of the **Proposed Te Tai o Poutini Plan**

**STATEMENT OF EVIDENCE OF STEPHEN JACK PEAKALL ON BEHALF
OF WEST COAST REGIONAL COUNCIL**

Dated 29 August 2024

ROAD NOISE OVERLAY WEST COAST
OVERVIEW

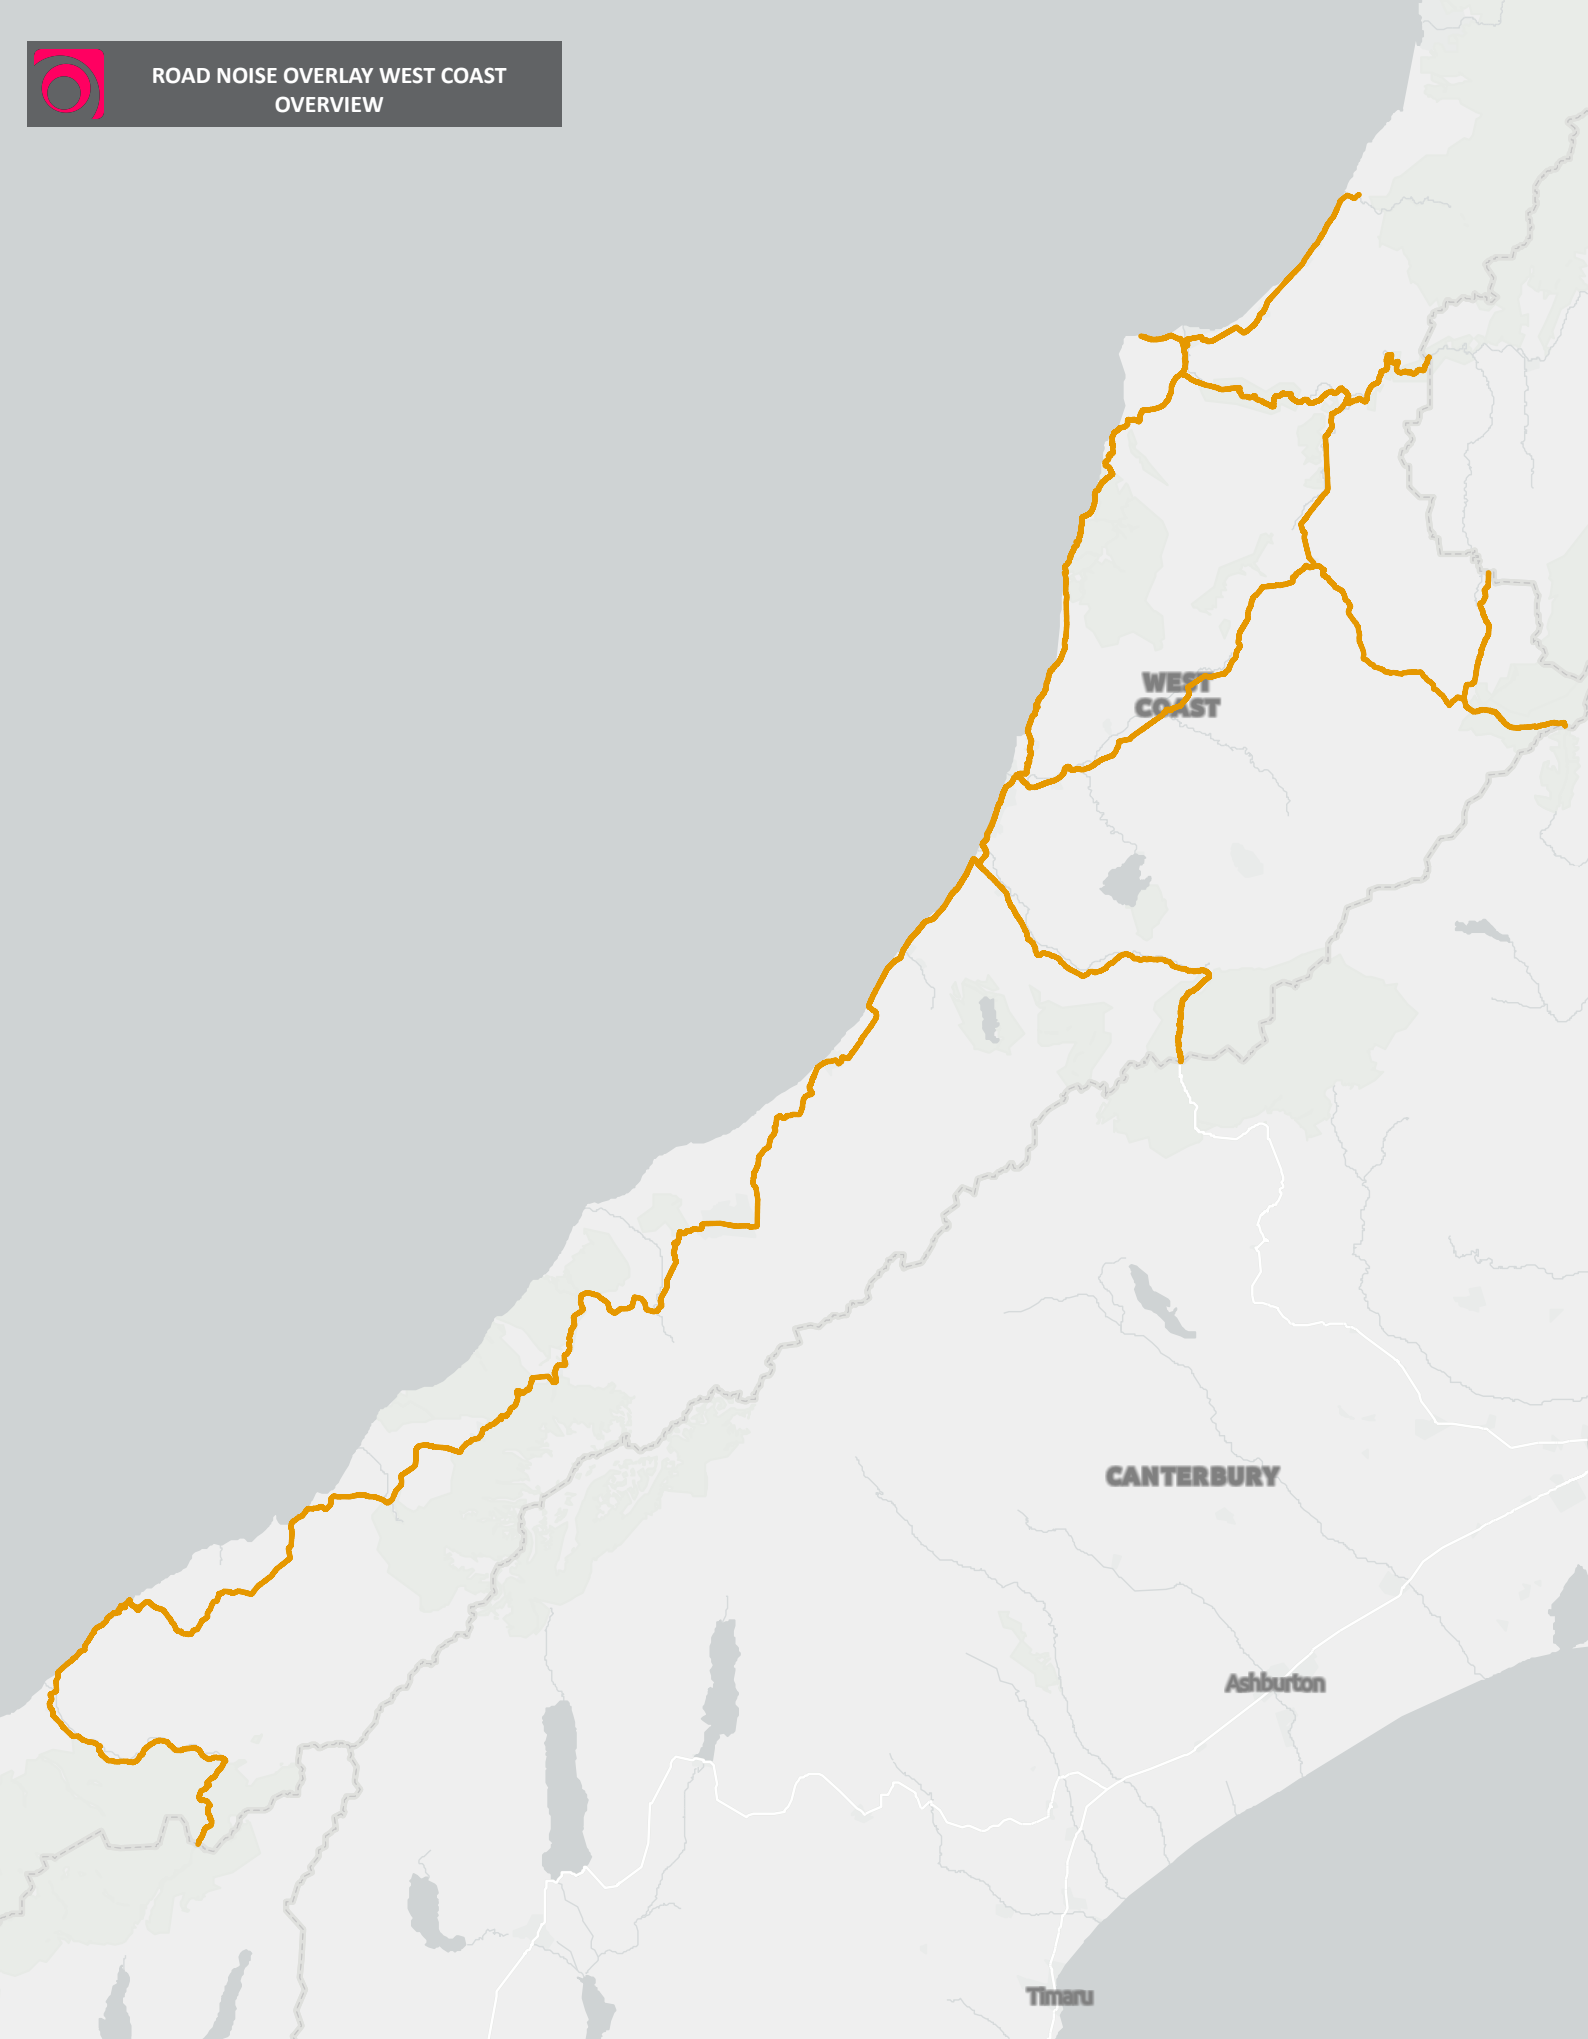
30. Dr Chiles evidence, and that of Mr Pearson on behalf of NZTA, support the use of an overlay instead of setback distances to inform where higher levels of highway road noise can occur and consequently where acoustic inclusion controls are required. For convenience I show the overlay as Figure 1 and 2 appended to this evidence. Figure 1 shows the overall extent of the overlay, and Figure 2 gives an example of how overlay varies depending on topography, screening, and other factors.

31. I have reviewed the overlay and agree it is an appropriate method to use; it would achieve acceptable outcomes if used, and the noise rules Ms Evans has prepared would be adequate to allow this to be implemented. These new rules would now no longer need the notified clause R3.1.b.ii relating to vehicle movement growth allowance of 3 decibels, as I understand this is already accounted for in the Overlay (refer Table 2, Appendix A of Dr Chiles' evidence).
